STATE OF NORTH CAROLINA
DEPARTMENT OF TRANSPORTATION

Subject: **Application for Modification of the Section 404 Individual Permit, Section 401 Water Quality Certification, and Riparian Buffer Certification** for the Continuation of Greensboro-High Point Road (SR 4121) on New Location in Guilford County, Federal Aid Project No. STP-4121(1), Division 7, TIP No. U-2412 A, Debit \$570 from WBS 34802.1.1.

**Minutes from the Interagency 4C Permit Drawing Review Meeting
U-2412A in Guilford County
September 21, 2017
NCDOT Century Center
10:00 AM – 12:00 PM**

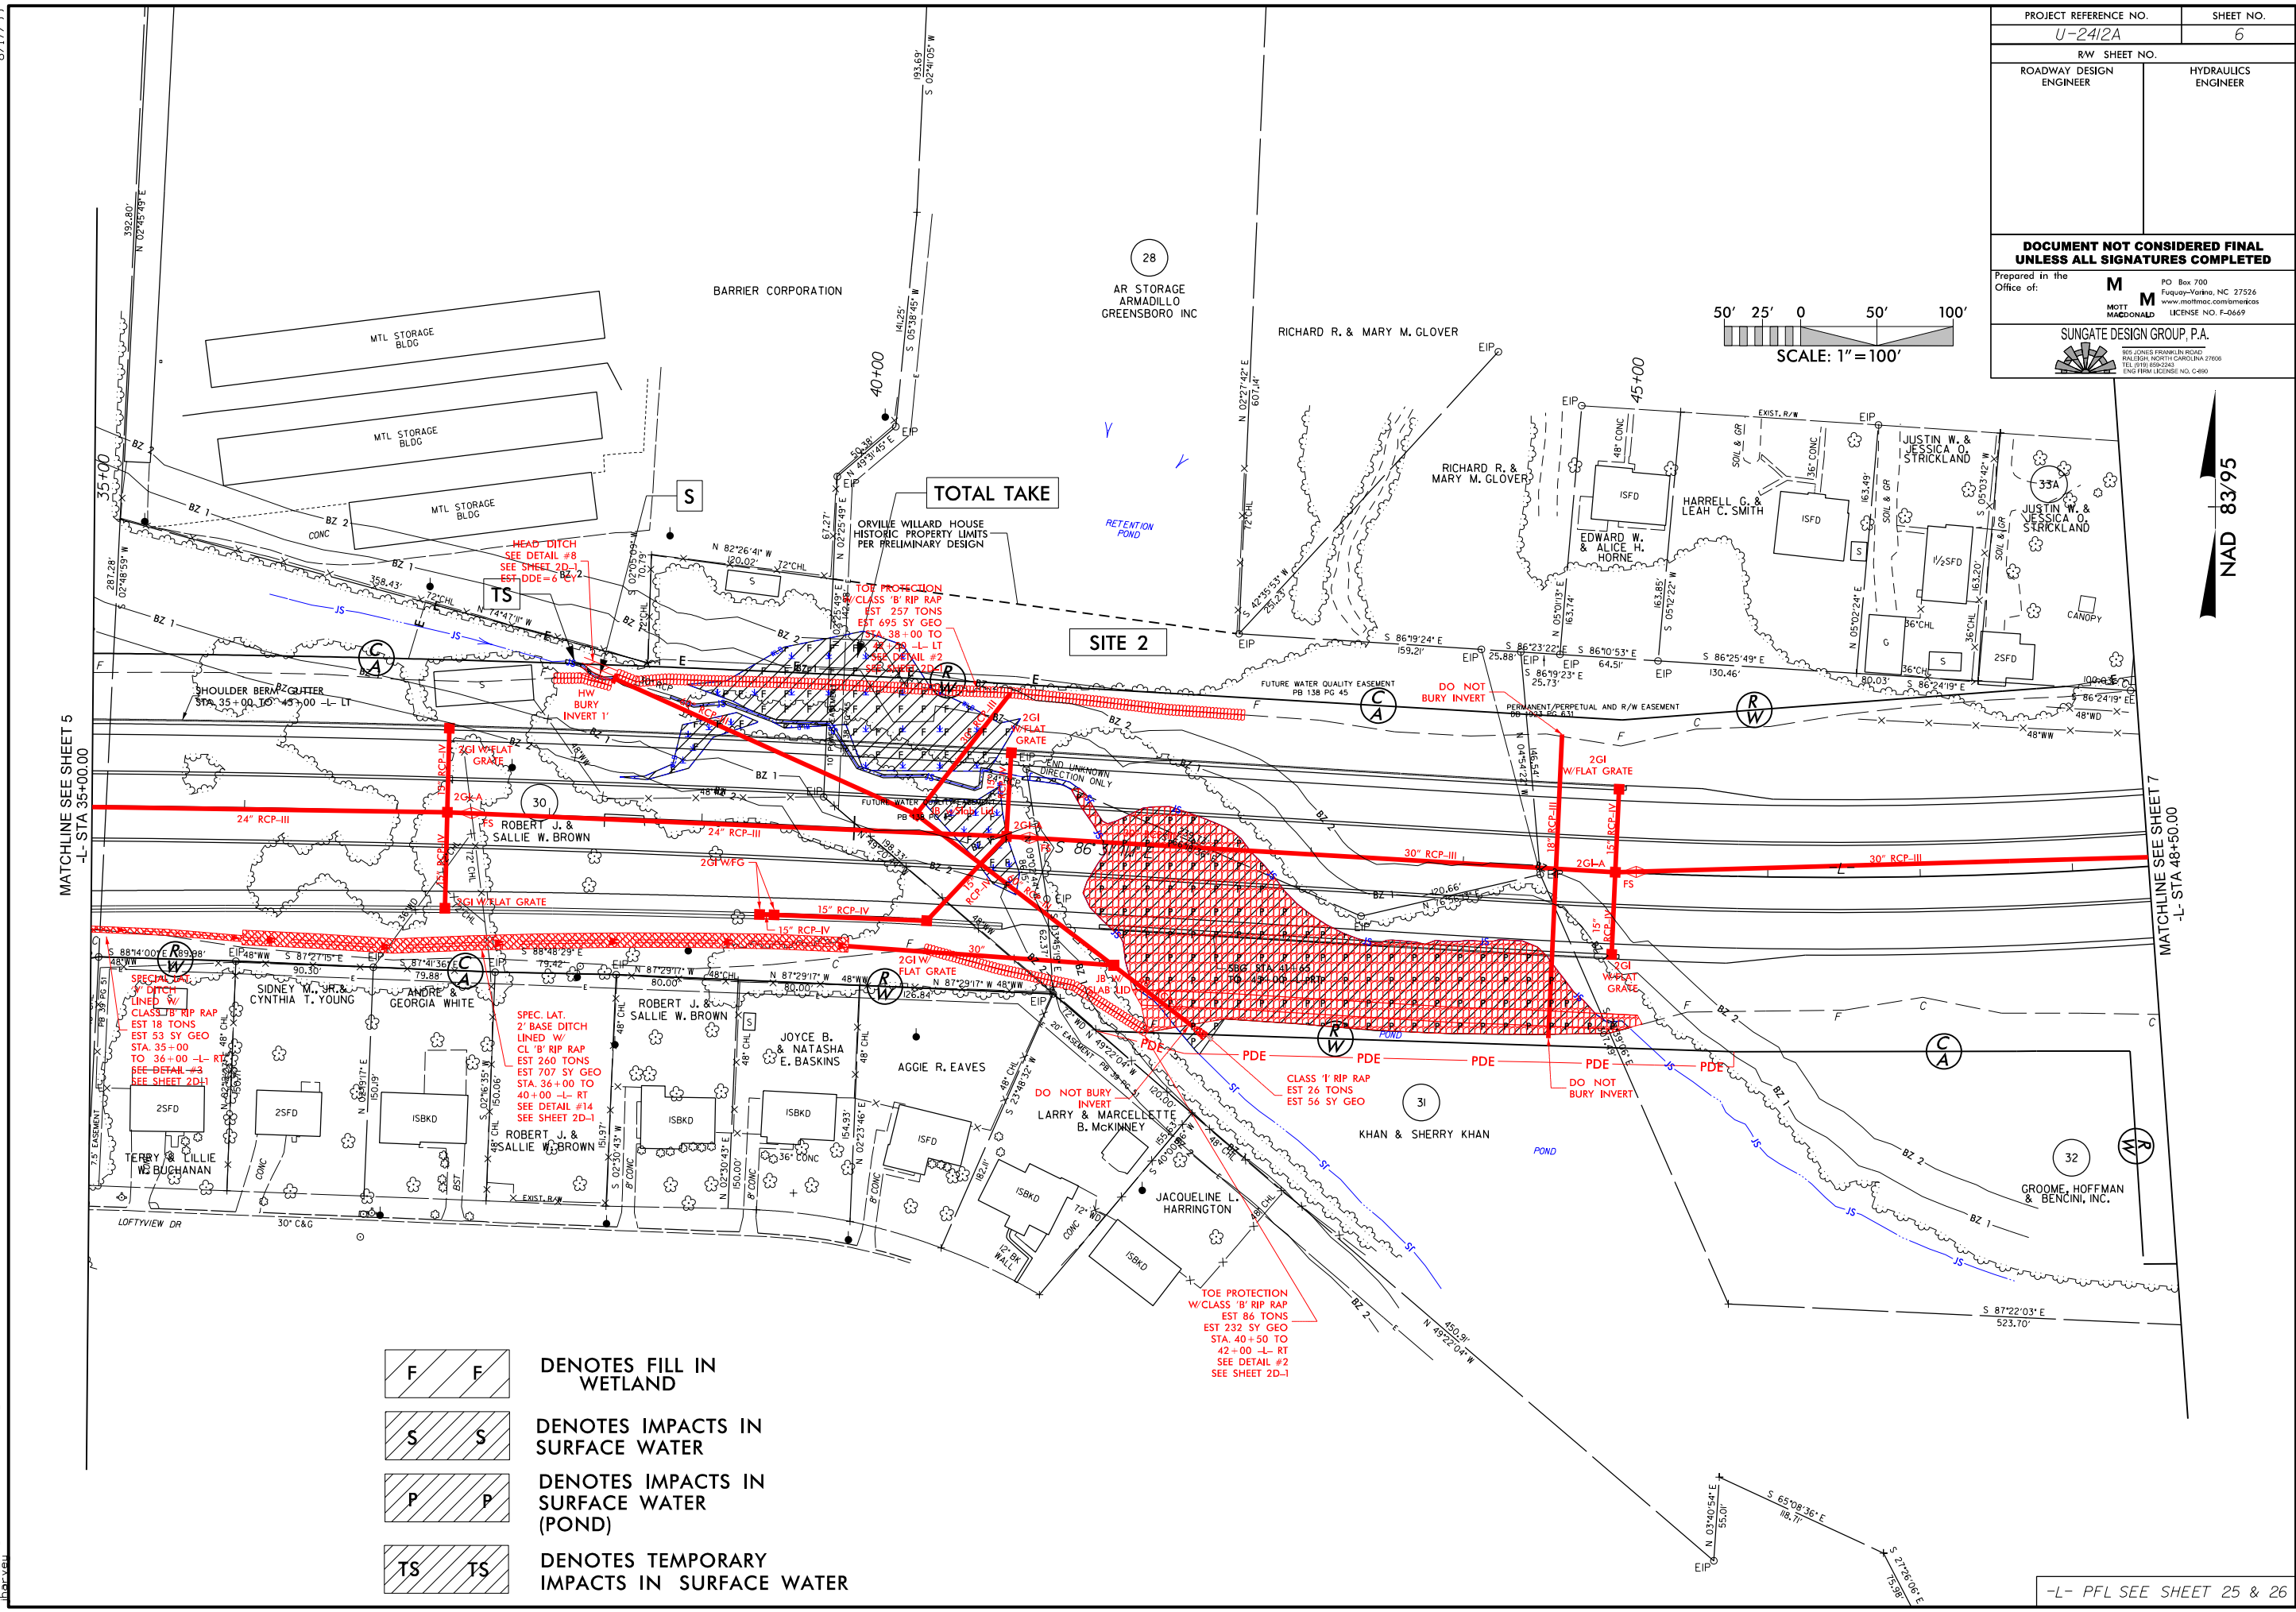
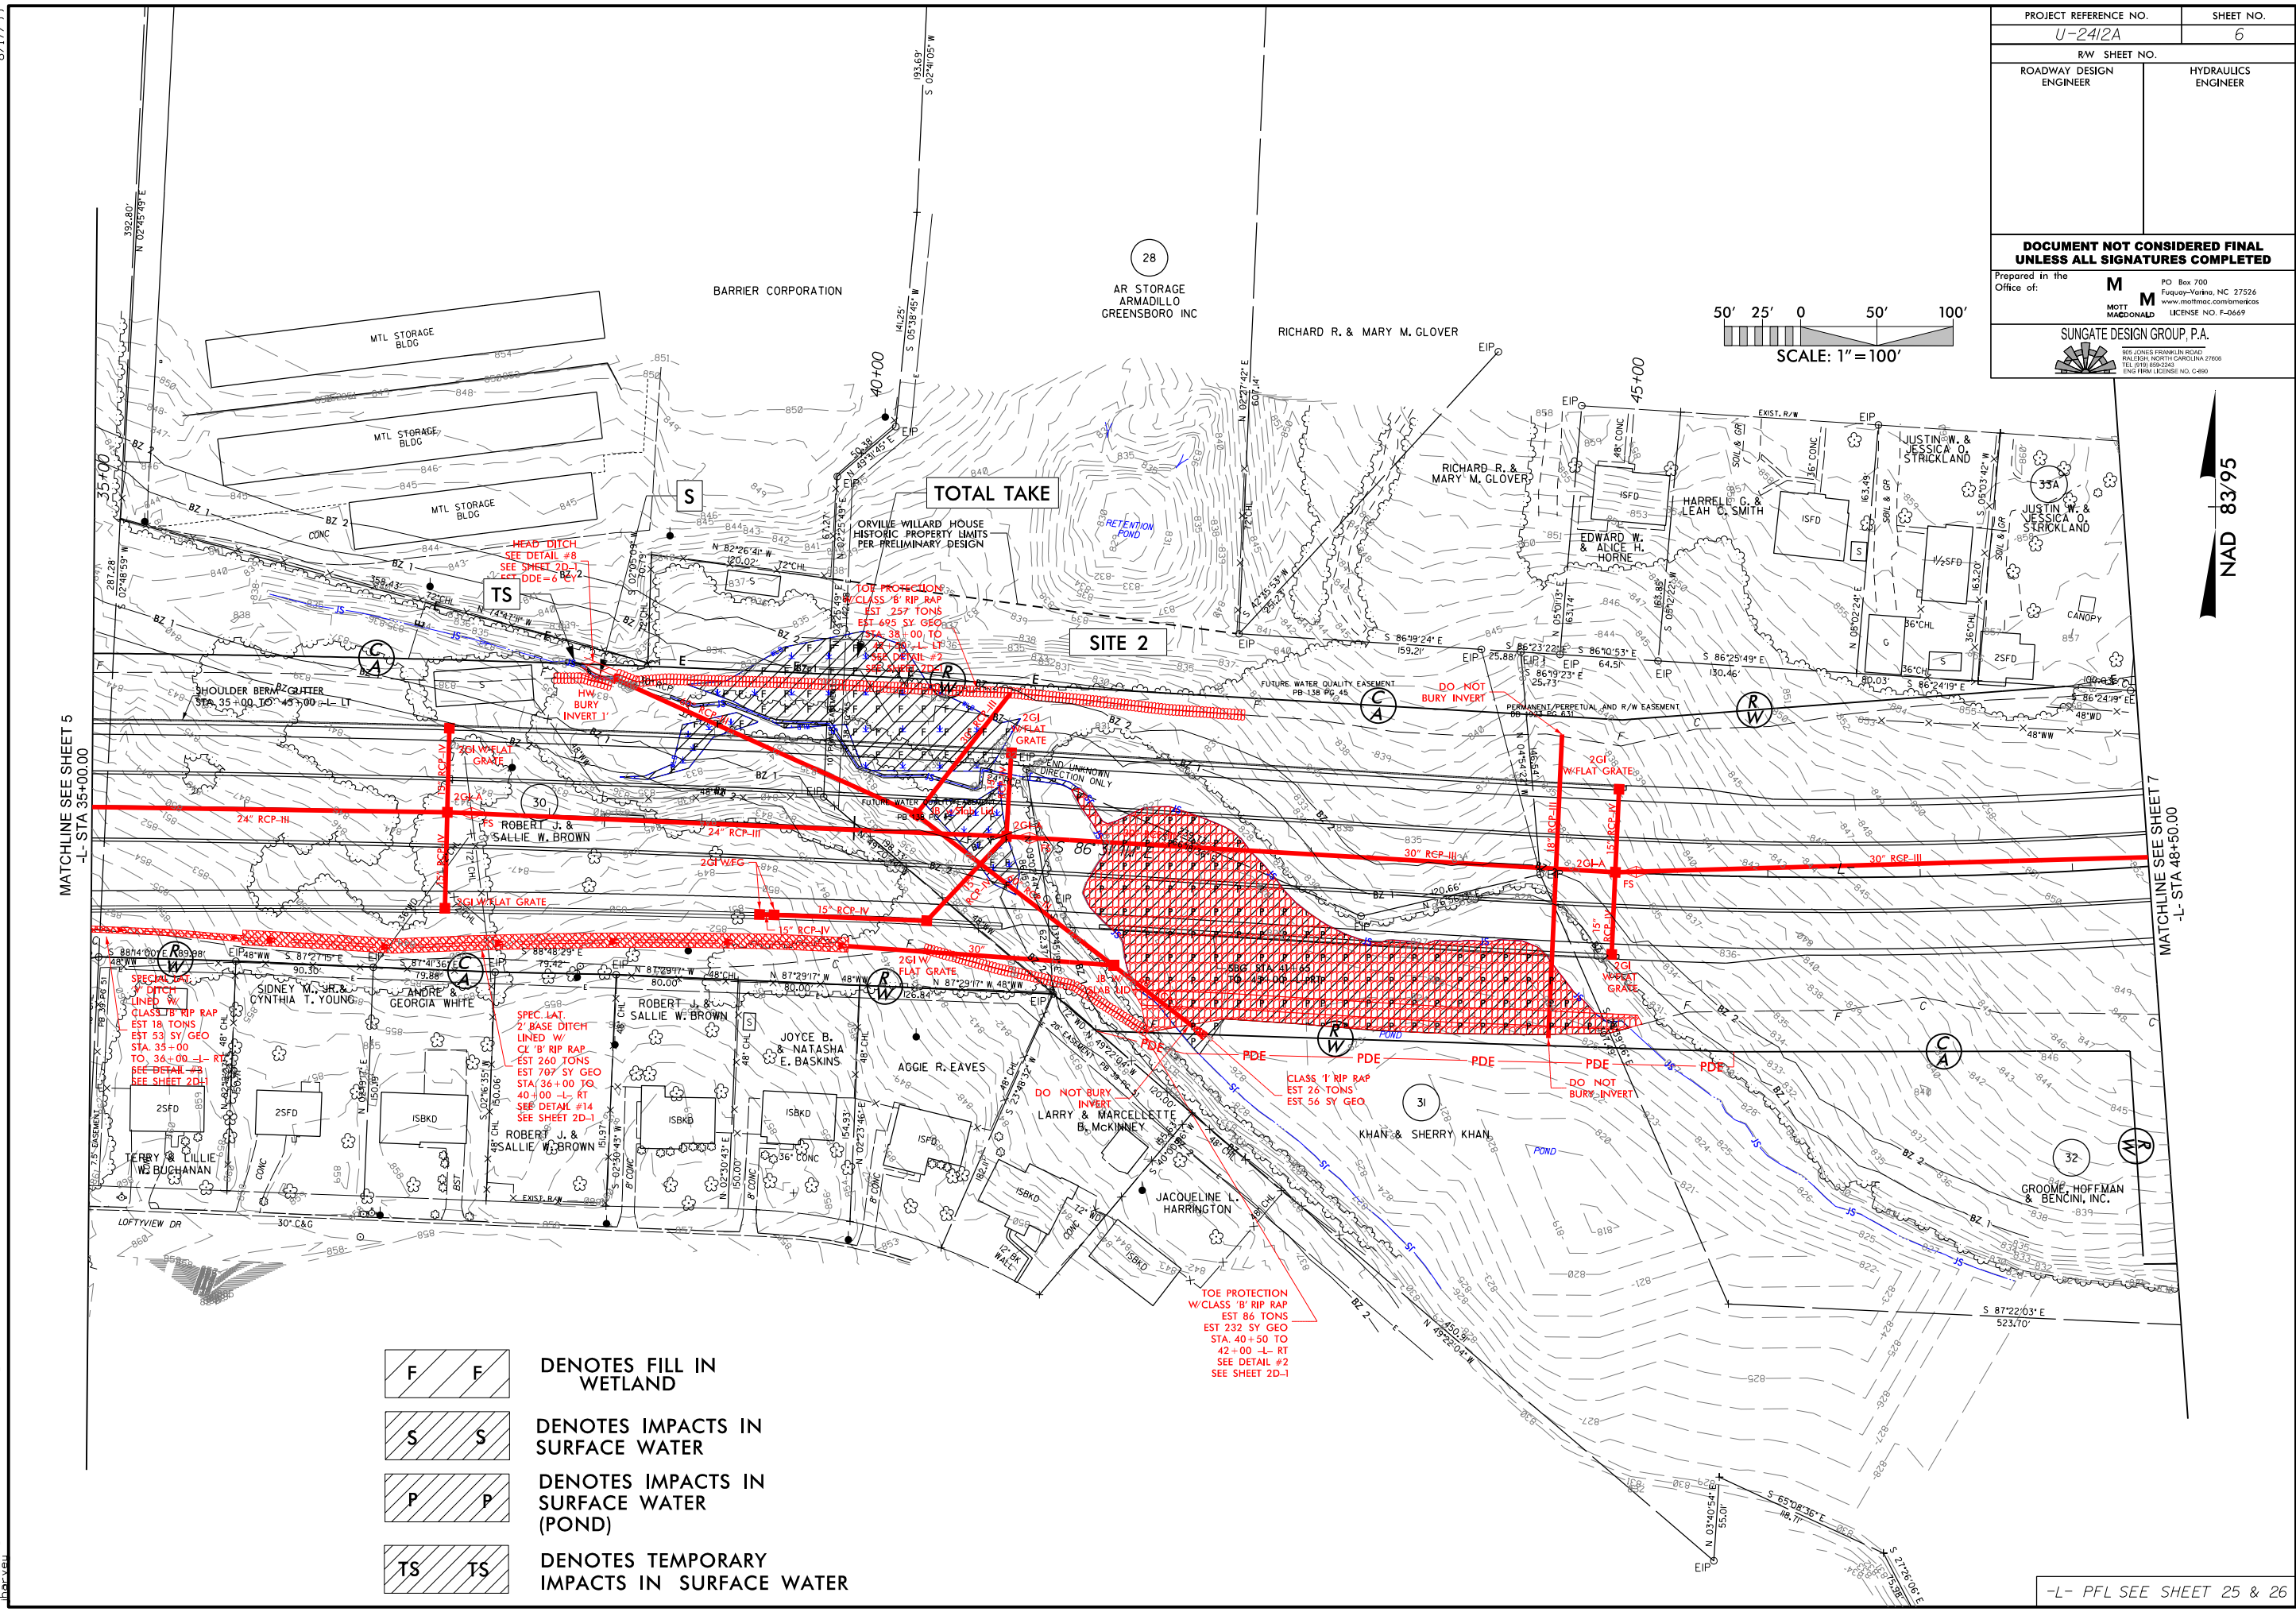
Site 2 (Plan Sheet 6):

- The proposed 60” pipe is on a flat slope (0.65%). 60” pipe inverts will match at the junction boxes and will not be drop boxes. Keep inlet invert for the 60” RCP buried.
- Wetland is considered a total take.
 - o Note on summary sheet with * and a footnote;
 - o Don’t hatch outside of easement.
 - o “Label as total take, accounted for in impact summary...”
 - o Easement limited by historic property.

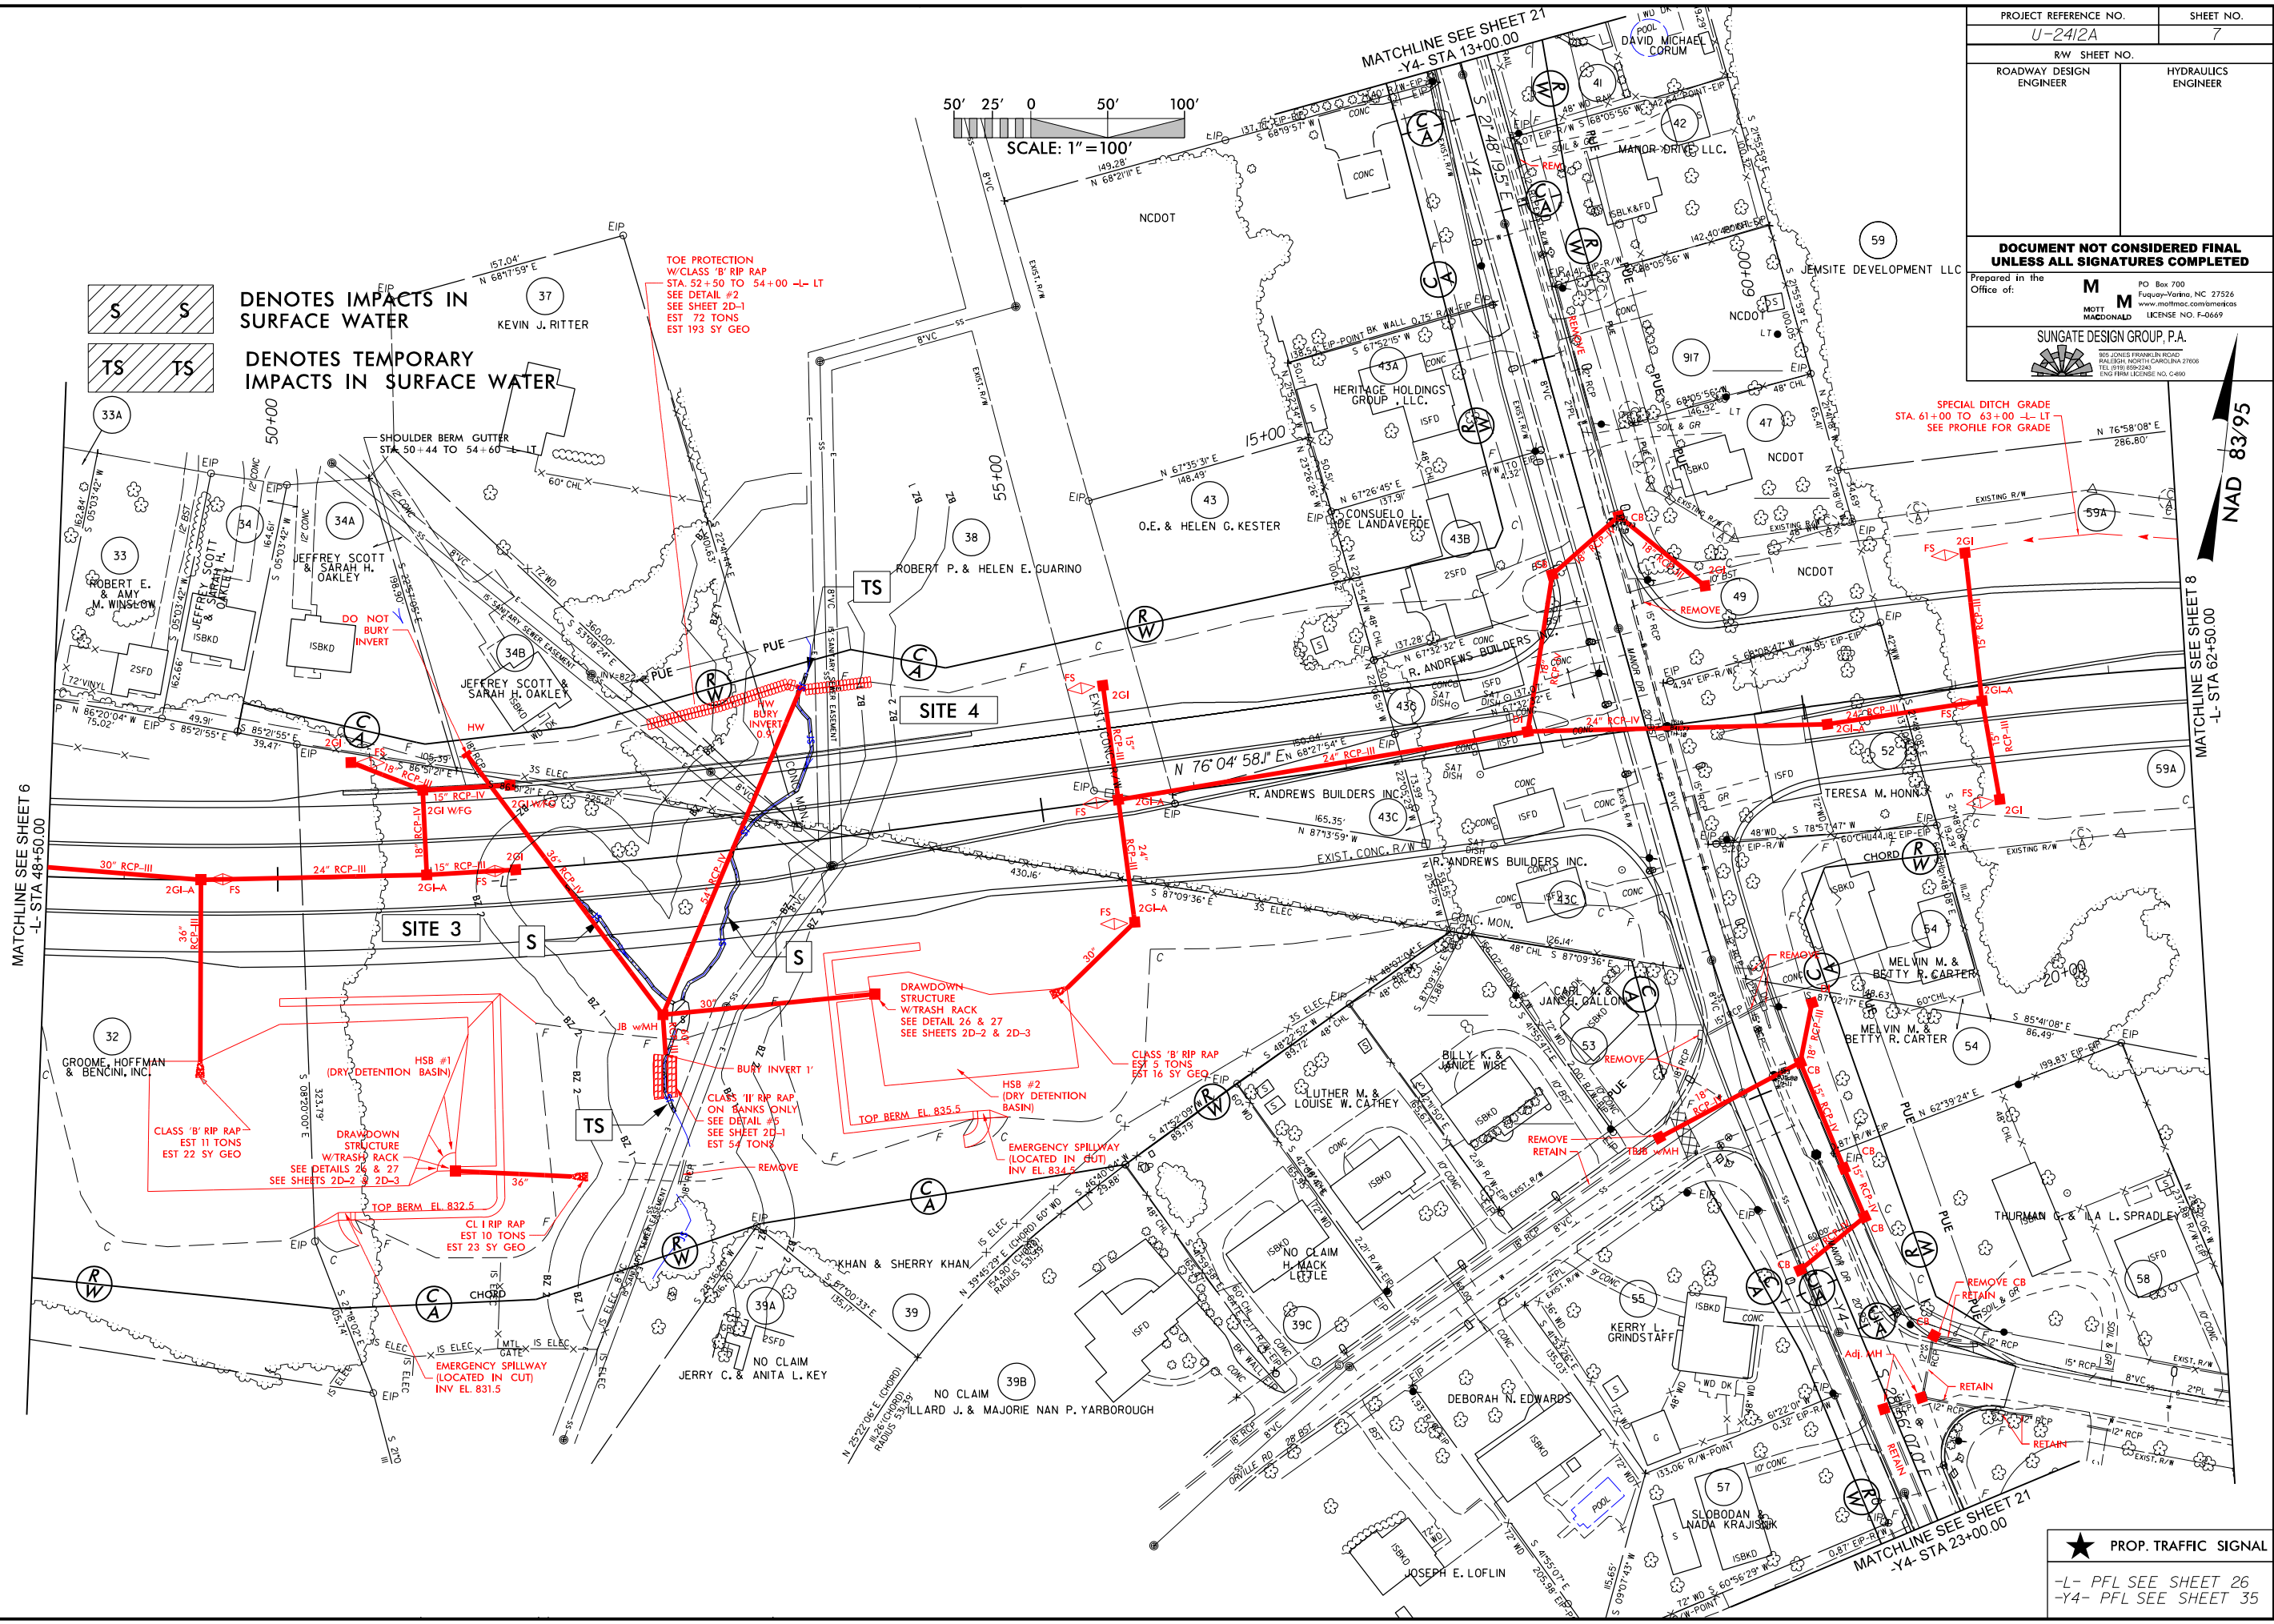
Site 3 (Plan Sheet 7):

- JS is non-mitigable. Do not change permit drawings. Leave the stream hatched, just note that it is non-mitigable in the permit application.
